2020 Corvette: GM TechLink: Removal of Corvette Z51 Spoiler

Removal of Corvette Z51 Spoiler

June 29, 2020 GM TechLink

Fig. 16

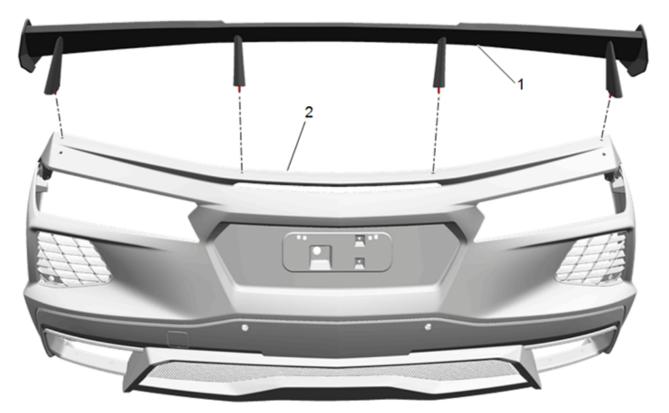
To remove the Z51 rear spoiler, it's recommended to use 50 lb. test monofilament fishing line. Position the line (Fig. 16, #1) between the spoiler and fascia and, with a sawing motion, move the fishing line through the two-way tape to remove the spoiler. Using the fishing line method will eliminate any possibility of damage to the painted fascia surface.

Do not use a heat gun, or attempt to pry the spoiler off the fascia with a plastic, metal or wood trim removal tool, in order to loosen the adhesive tape.

The installation instructions for Rear End Spoiler Package Installation (Fig. 17) in the Accessories Manual in the Service Information have been updated to eliminate the use of a heat gun to soften the two-way tape. Follow the updated installation instructions and do not use a heat gun during the removal process.
